# SERVICE INSTRUCTION

## RUNNING MODIFICATIONS ON

### ROTAX® ENGINE TYPE 912/914 (SERIES)

#### SI-912-020

### 1) Introduction of a new flexible fuel line assy. part no. 874910 for ROTAX® 912 Series

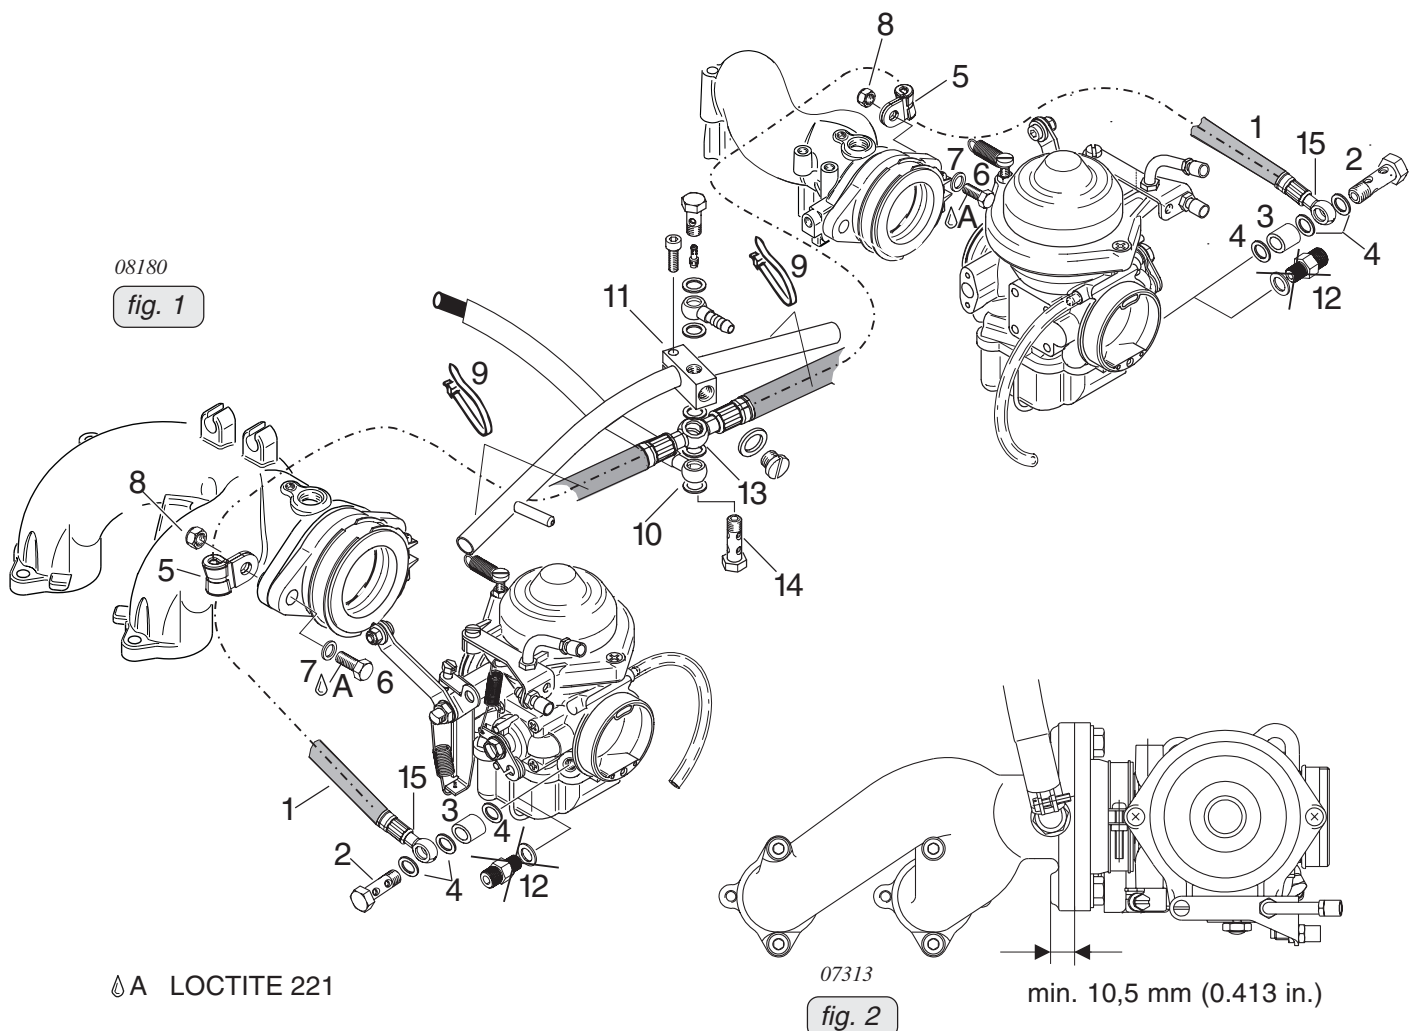
In the course of continuous development and for better assembly and maintenance a new flexible fuel line (part no. 874910) has been introduced.

Installation of this new fuel line requires the following modifications:

- mechanical machining at the intake manifold for the attachment of the cable clamp. At engine repair/general overhaul be aware that the fixation of the flexible fuel line needs an appropriate contact surface. If necessary replace the intake manifold or machine the contact surface according to the following instruction.

- Install the flexible fuel line (1) with the double ring hose nipple (13) and sealing ring (10) on the clamp block (11). Tightening torque of banjo screw (14) 10 Nm (90 in. lb.) (see fig. 1).

- Install the ring hose nipple (15) with distance sleeve (3) and sealing ring (4) on the carburetors . Tightening torque of banjo screw (2) 10 Nm (90 in. lb.)

- For installation on an old style intake manifold perform the following: Remove the intake manifold and machine the nut/clamp contact area until the surface is parallel with the sealing surface of the carb socket. The thickness of the material must not be dressed down less than 10,5 mm (0.413 in.) and should be smooth and flat so that the nut/clamp assembly has an even contact surface (see fig. 2).

- Ensure proper support of the flexible fuel line. Install Hex. screw (6) and washer (7) with 15 Nm (133 in. lb.). Install the cable clamp (5) at the hex. screw (6) of the carburetor socket with the hex. nut (8). Tightening torque of hex. nut (8) 24 Nm (213 in. lb.)

fig. 1

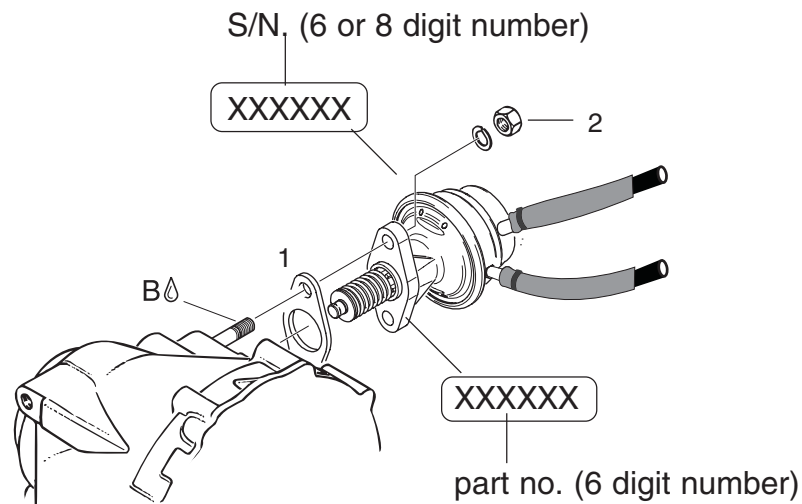
In the course of continuous development a new gasket (1) (part no. 950226) has been introduced.

The gasket is interchangeable.

- ◆ NOTE: On the sealing surfaces of the gearbox housing and the fuel pump no sealing compound has to be used.

fig. 1

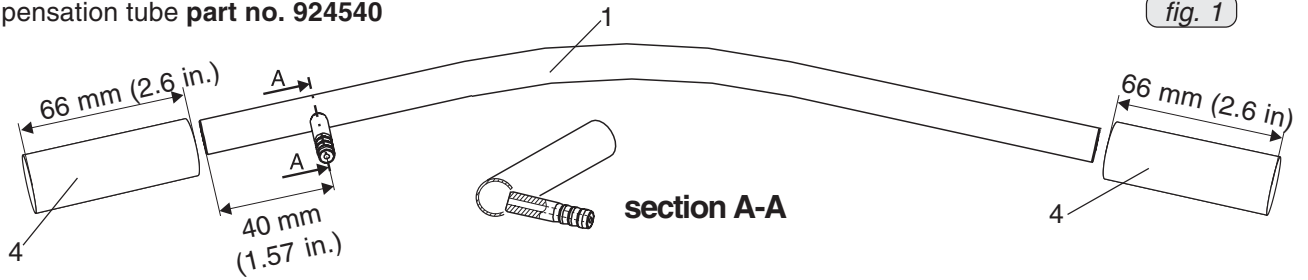
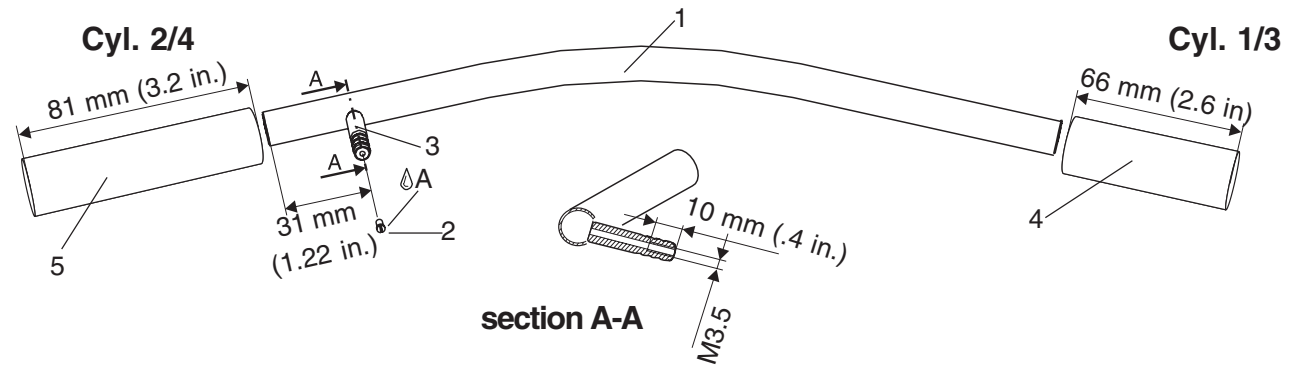
In the course of continuous development a new compensation tube (1) (part no. 924541) has been introduced which the synchronization to make it easier, the tube must not removed.

In this connection the following modifications became necessary:

- position of connection fitting (3) on compensation tube remains approximate constant
- additional screw (2) part no. 940980 for connection fitting (3)
- new tube (4) part no. 956143 (5) part no. 956141

◆ **NOTE:** In case of interchangeable it is not possible to exchange individual parts. The new compensation tube are only **together** interchangeable with the tube part no. 956141. In case of spare parts the relevant configurations must be observed.

fig. 2

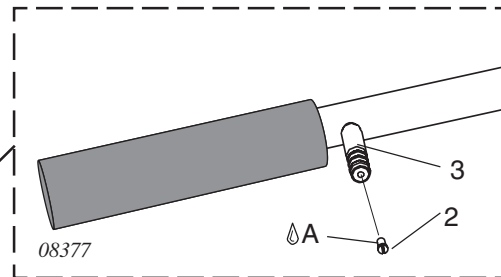
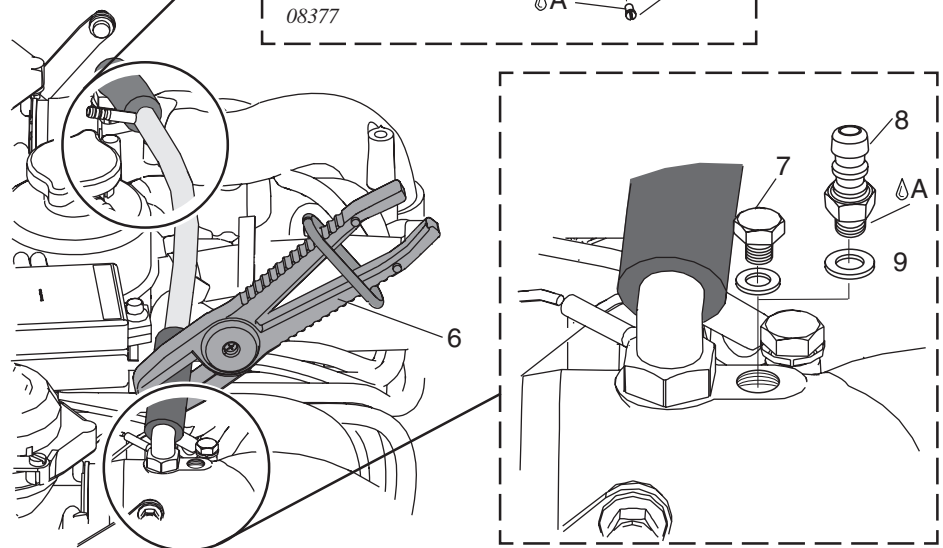
1. Install the vacuum gauge.
2. Clamp the tube with hose clamping pliers (6). Observe the position! The tube (1) must not removed.
3. Unscrew the screw (7).
4. Install the hose nipple M6 (8) with the sealing ring (9).
5. After synchronization tightened the screw M6x6 (7) with LOCTITE 221.

1. Unscrew the screw (2) from the connecting fitting (3) for indicating instrument.

◆ **NOTE:** If it is not possible to stabilize the intake manifold pressure, tighten the screw M3.5x6 (2) with LOCTITE 221. Install color markings on the screw.

## 1.) Introduction of a new expansion tank assy.

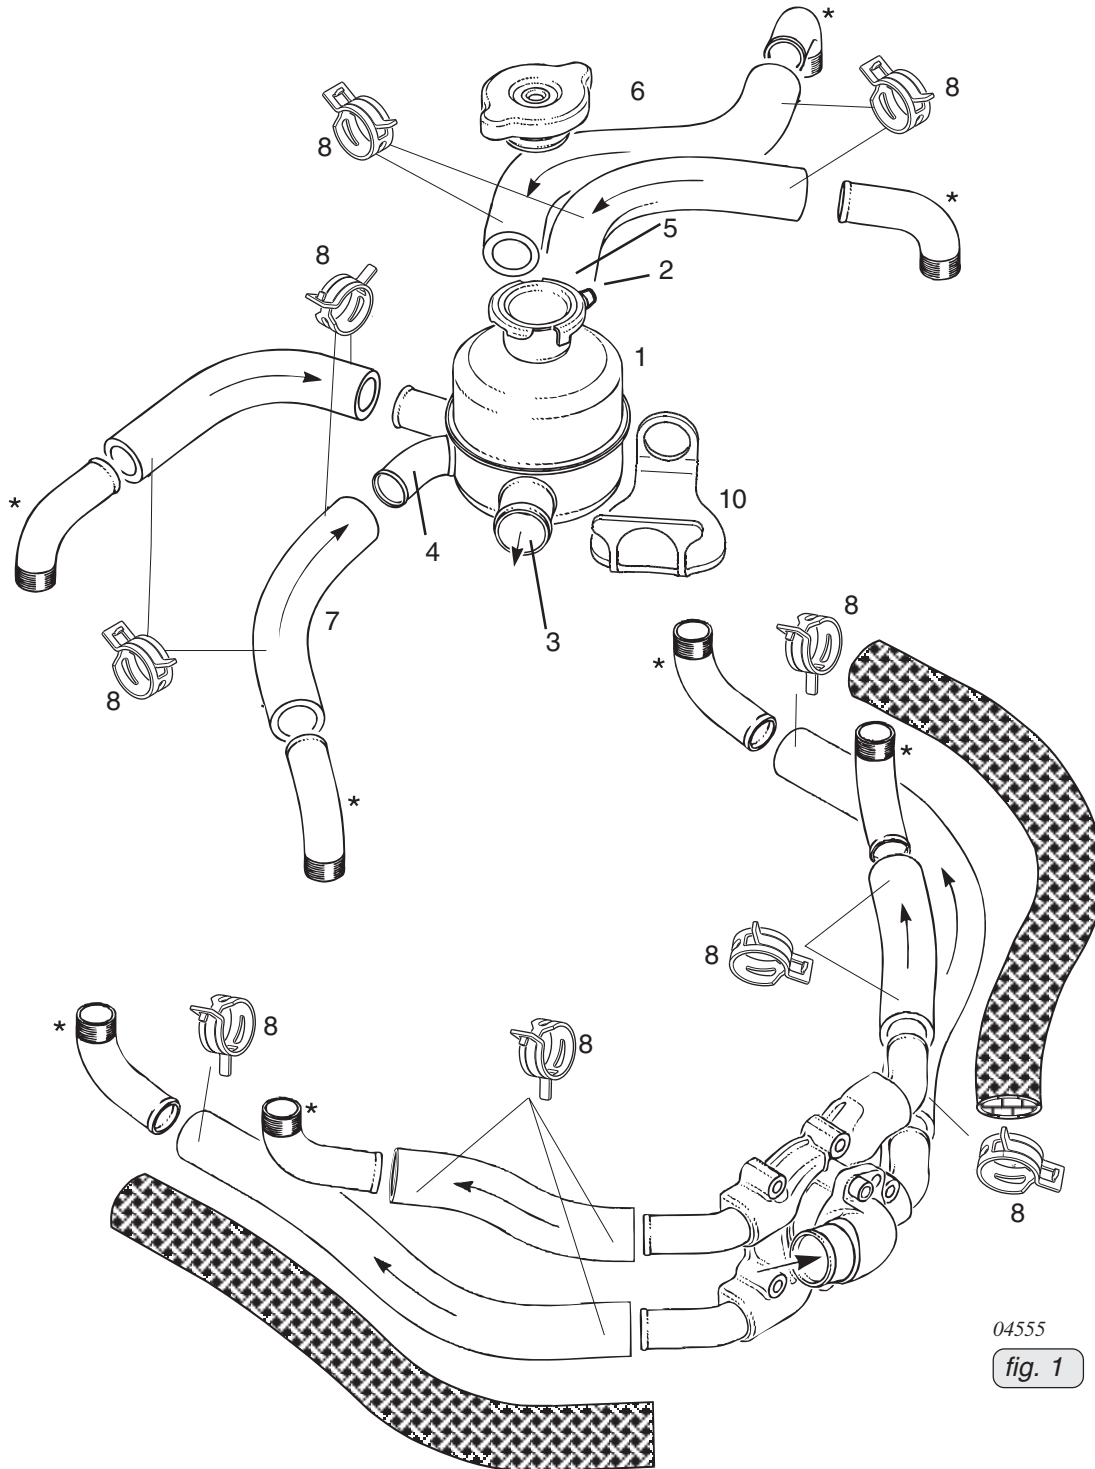
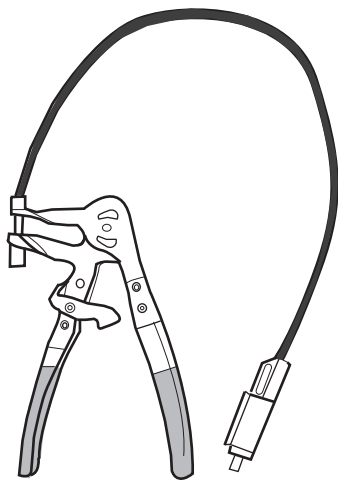
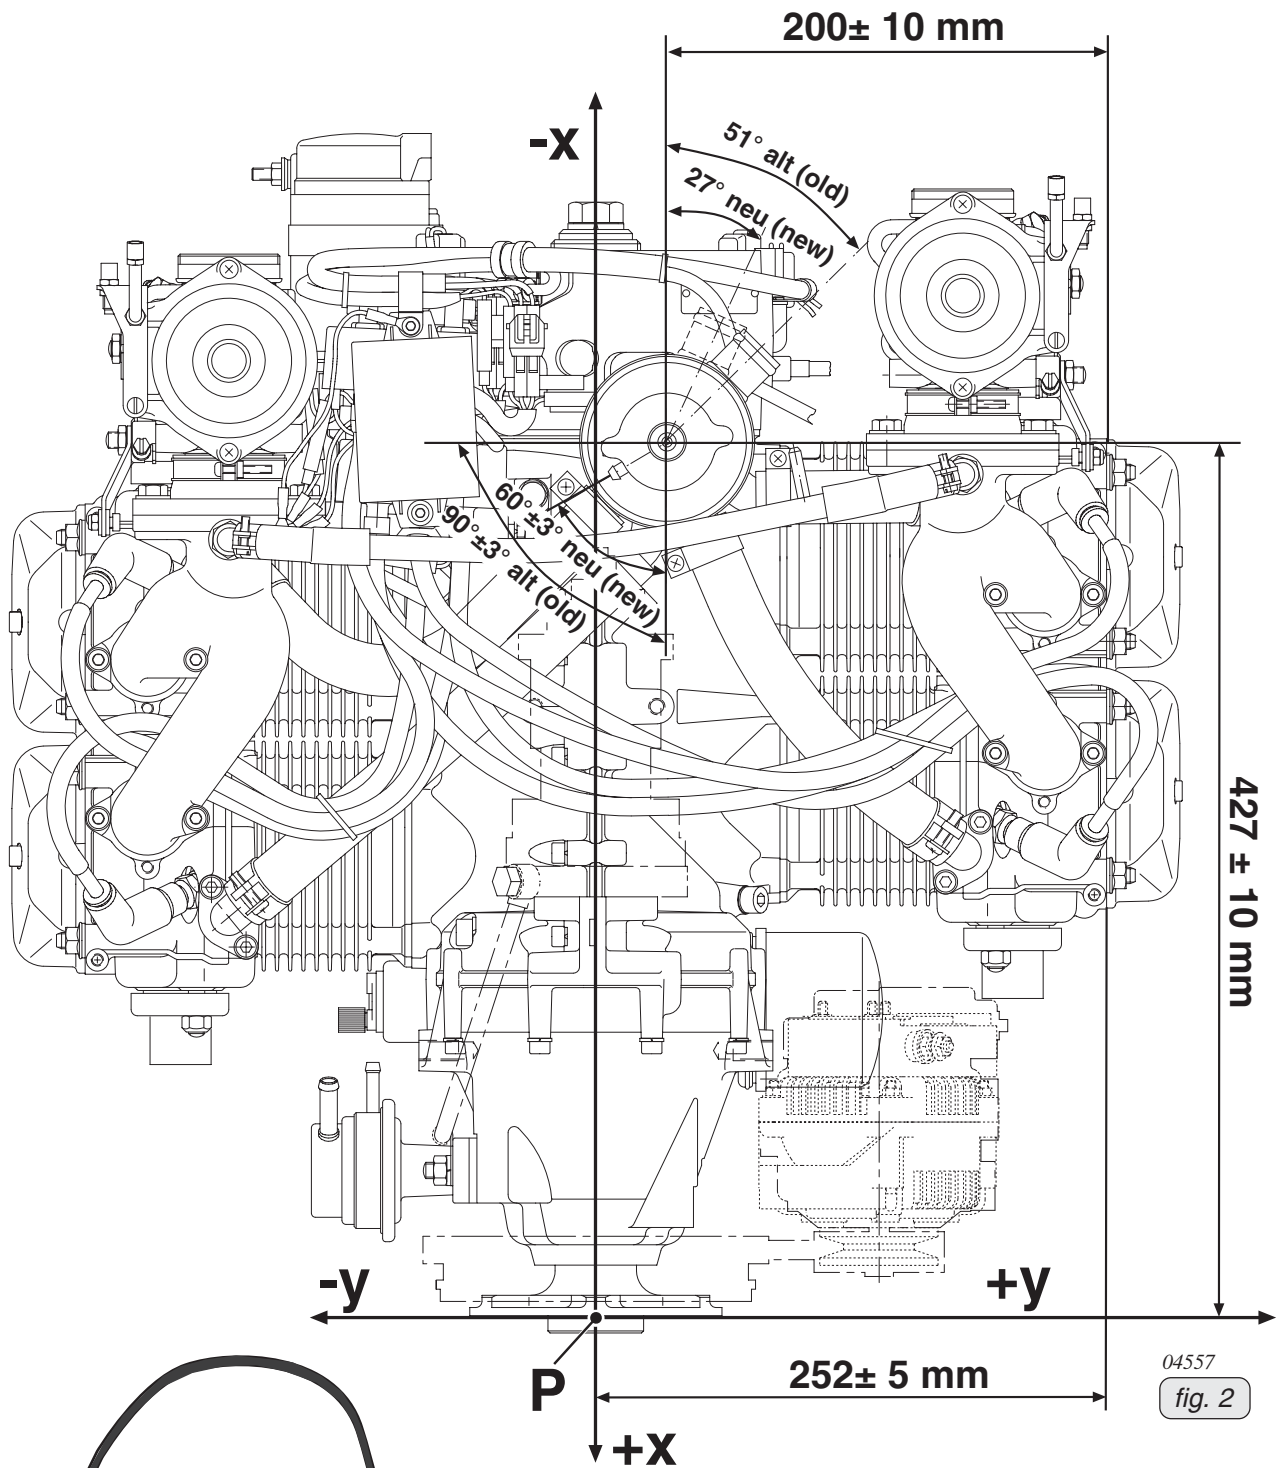
In the course of further development and standardization the position of the expansion tank (1) has been optimized!

In this connection the following modifications became necessary:

- position of connection (2) to overflow bottle (from 0° to 30±3°)
- position of connection (3) to radiator (from 51° to 27±3°)
- angle of inlet socket (4) from cylinder 4 (34° inclined)
- length of inlet socket (5) from cylinder 3 (length increased by 13,4±3 mm)
- length of coolant hose (6) from cylinder 1 (length increased from 270 mm to 285 mm)
- length of coolant hose (7) from cylinder 4 (shortened from 100 mm to 85 mm)
- new spring type hose clamps (8) to attach the coolant hoses (expansion tank and water pump)

- Install the coolant hose (6) 285 mm to cylinder 1 and the new coolant hose (7) 85 mm to cylinder 4. For attaching all the coolant hoses from expansion tank, water pump, cylinders, use the new spring type clamps.

■ **CAUTION:** Take care of appropriate slip-on length of the coolant hoses on the corresponding connection socket. Verify tight fit of clamps and hoses and check for leakage. Always fit the clamps such that they can not wear on any component and use a suitable tool (see fig. 3) for fitting them.

Variant 1

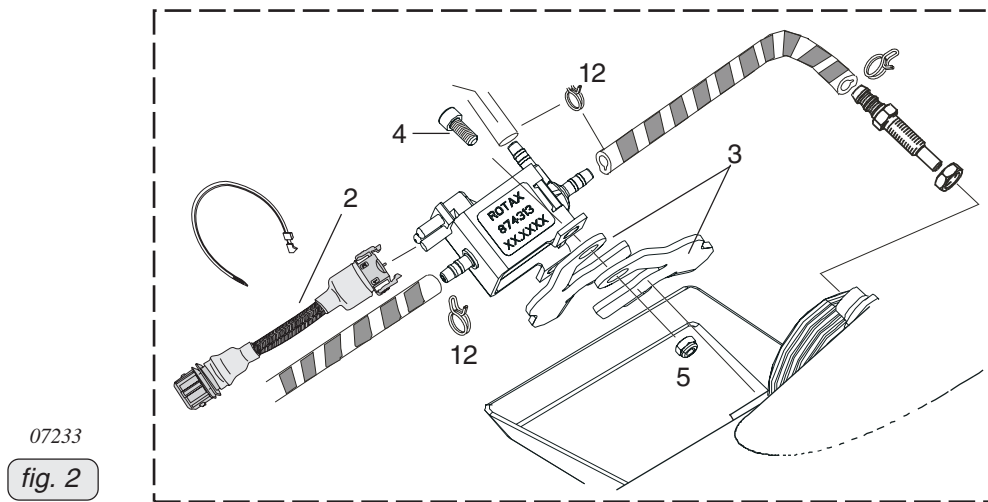
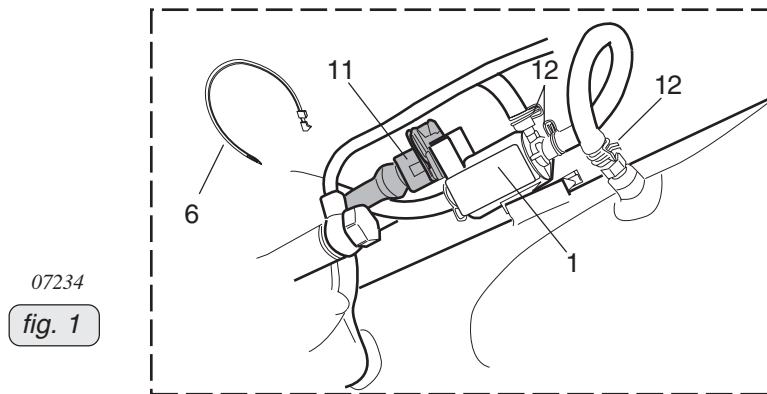
Owing to change of supplier from the new 3-way solenoid valve (part no. 874313) an adapted wiring harness and an airbox part no. 667574 have been introduced.

Remove connection wiring harness (11) of 3-way solenoid valve (1).

Cut off tie wraps (6).

Loosen 3x clamps (12) from 3-way solenoid valve and remove lines.

Remove 3-way solenoid valve.

Connect adapter cable (2) to wiring harness.

Install bracket (3) onto airbox.

Tighten 3-way solenoid valve with allen screw (4) and lock nut (5). Tightening torque 8 Nm (70 in.lb).

07231  
fig. 4

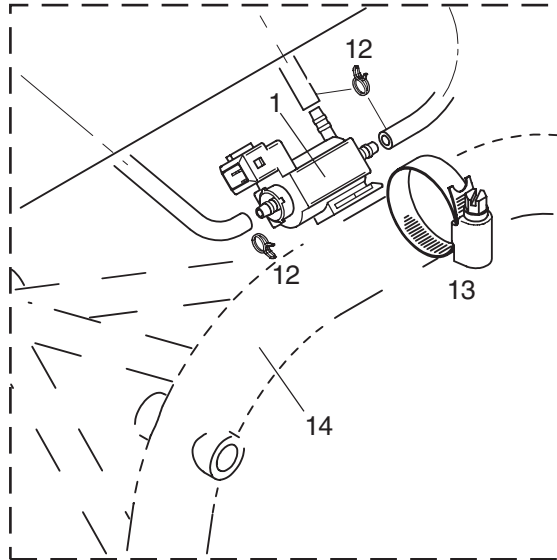
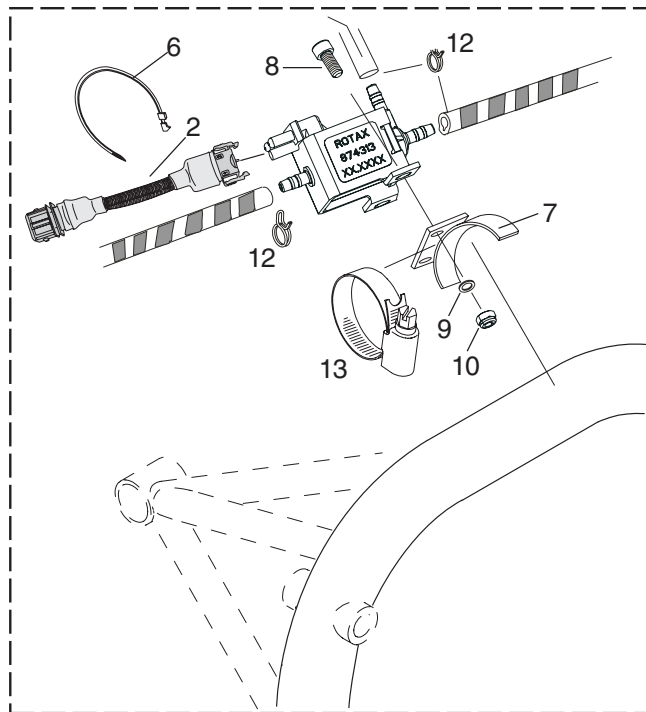
Remove connection wiring harness (11) of 3-way solenoid valve (1).

Loosen clamps (13) from engine suspension frame (14) and remove 3-way solenoid valve.

Tighten the new 3-way solenoid valve with allen screw (8), washer (9) and lock nut (10) onto bracket (7). Tightening torque 8 Nm (70 in.lb).

Install 3-way solenoid valve with clamp (13) onto engine suspension frame.

new Version

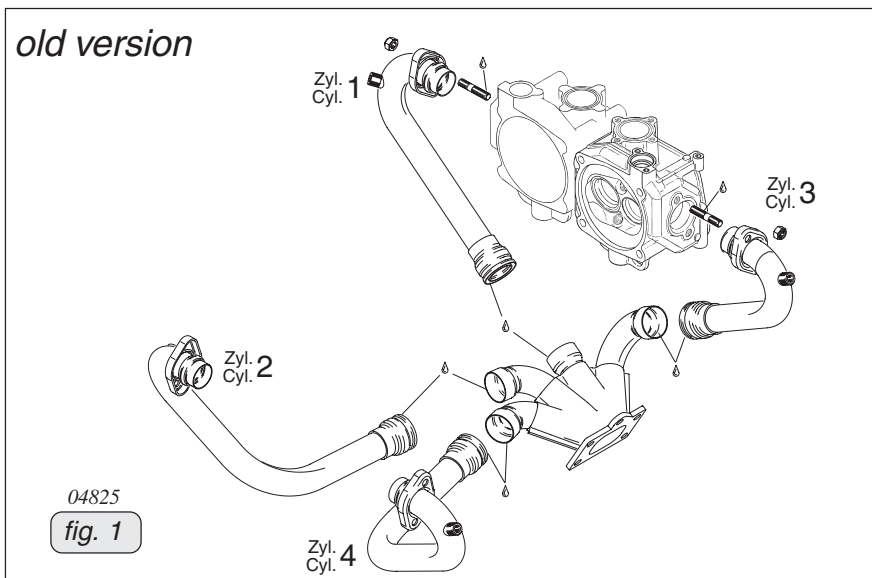
Owing to continuous further development, the exhaust bends were slightly re-worked. The couplings were optimized for their position.

- Position of the EGT connections (6) to the exhaust bends for cylinders 3 and 4 were routed such that installation of the new drip trays is possible.

◆ NOTE: If replacement of any single old part number is necessary, you must replace it with the same old part number. If the old part number is not available, the entire assembly including all 4 pipes and manifold must be replaced with new part numbers. New style pipes and manifold are not interchangeable with old style.
